AGENDA

NEC Code-Making Panel 4 (NEC P04) NFPA 70 Second Draft Meeting (Annual 2025)

October 14 - 16, 2024
8:00 a.m. – 5:00 p.m. (PT)

Figure Informational Note 690.1 Illustration of PV System DC Circuits and PV System Components in a Typical PV Installation.

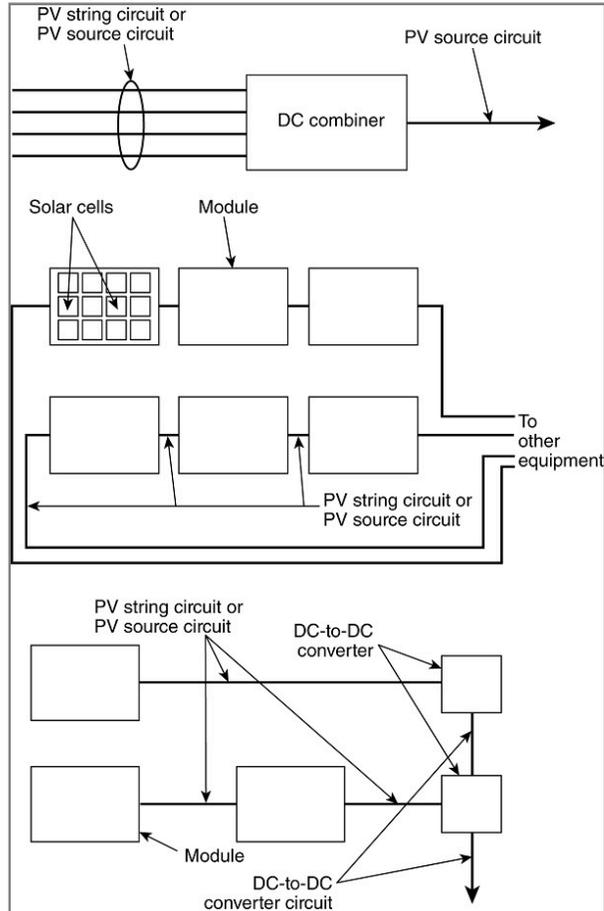
Statement of Problem and Substantiation for Public Comment

Figure Informational Note 690.12(D) Label for Roof-Mounted PV Systems with Rapid Shutdown.

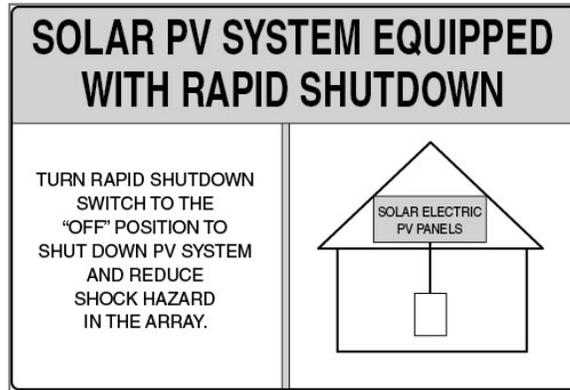
Statement of Problem and Substantiation for Public Comment
